CONSERVATION TEAM CONSULTATION APPLICATION RESPONSE

APPLICATION REF:	26/01795/FPH & 26/01796/LBC
CASE OFFICER:	TK
APPLICATION SITE:	46 Ridge Road, Letchworth Garden City, Hertfordshire, SG6 1PN
DESCRIPTION OF WORKS:	Single storey rear extension following demolition of existing lean-to.

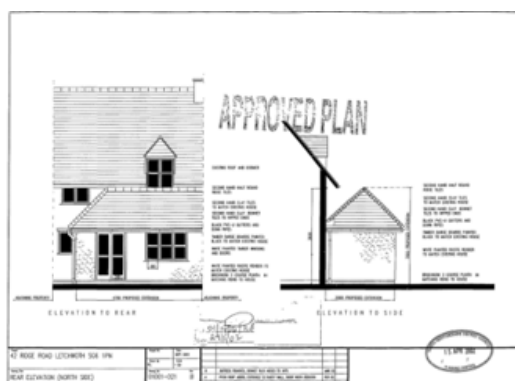
Rear single-storey extensions schemes to the listed, even-numbered properties at Ridge Road, have followed a generally broad format of tiled pitched roofs additions with one exception. The most recent scheme of this type related to no. 27 Birds Hill around the corner where a flat-roof design was negotiated away and consent granted for the right-hand scheme below which has a flat roof light on a section of flat roof.

*The current scheme also seeks a parapet, flat-roofed addition and once again considering the tiled mono-pitch projections to nos. 118 and 122 on either wide and **where there has been a consistent approach to supporting tiled, pitched roof extensions over the years**, I question whether this is appropriate to the character of the host building and the terrace to which this forms part.*
